# Access Compliance Report

## Public Rights-of-Way

Intersection ID: 8515	Main Street: ATANDO_AV	Cross Street: STATESVILLE_AV	Location: SE
ADA ID: 6DE71683ECA	Ramp Type: Perp	Initial Pass/Fail: Fail	Overall Compliance: No
			Severity Score: 21.25

#### Codes/Mitigation Info/Possible Solution

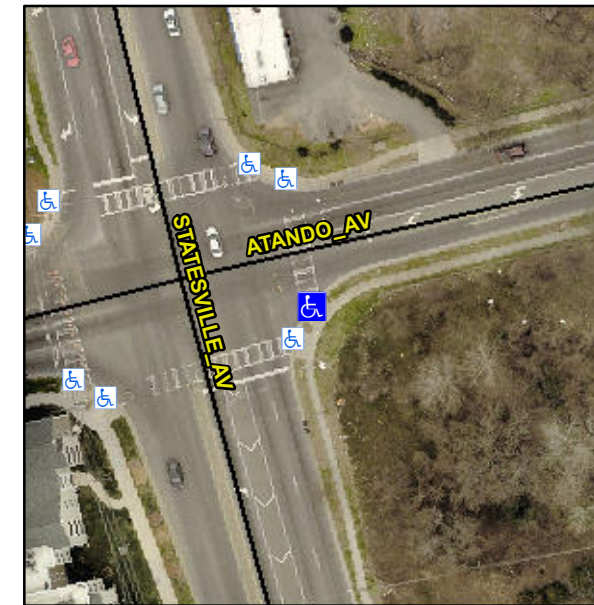
**R304.5.1, R304.2.2**

Compliance	Description	Data	Compliance	Description	Data
N/A	Ramp Length (in)	62.0	No	Ramp Slope (%)	10.3
No	Ramp Width (in)	42.0	Yes	Ramp XSlope (%)	1.3
N/A	Flare Type LT	N/A	N/A	Flare Type RT	N/A
N/A	Flare Slope LT (%)	N/A	N/A	Flare Slope RT (%)	N/A
N/A	Flare Traversable LT?	N/A	N/A	Flare Traversable RT?	N/A
N/A	Landing Length (in)	N/A	N/A	DWS Provided?	N/A
N/A	Landing Width (in)	N/A	N/A	DWS Contrast?	N/A
N/A	Landing Slope (%)	N/A	N/A	DWS Length (in)	N/A
N/A	Landing X Slope (%)	N/A	N/A	DWS Full Width?	N/A
N/A	Landing Curb? (Y/N)	N/A	N/A	DWS Offset (in)	N/A
N/A	Shared Landing?	N/A			
N/A	Gutter Ponding?	N/A	N/A	Gutter Slope (%)	N/A
N/A	Gutter Lip Ht (in)	N/A	N/A	Gutter X Slope (%)	N/A
N/A	Painted X Walk1?	Yes	N/A	Painted X Walk2?	N/A
	X Walk 1 Direction	To N		X Walk 2 Direction	N/A
N/A	X Walk 1 Width (in)	105.0	N/A	X Walk 2 Width (in)	N/A
	X Walk 1 Slope (%)	2.6		X Walk 2 Slope (%)	N/A
	X Walk 1 X Slope (%)	0.3		X Walk 2 X Slope (%)	N/A

**Remove & Replace Entire Ramp.**
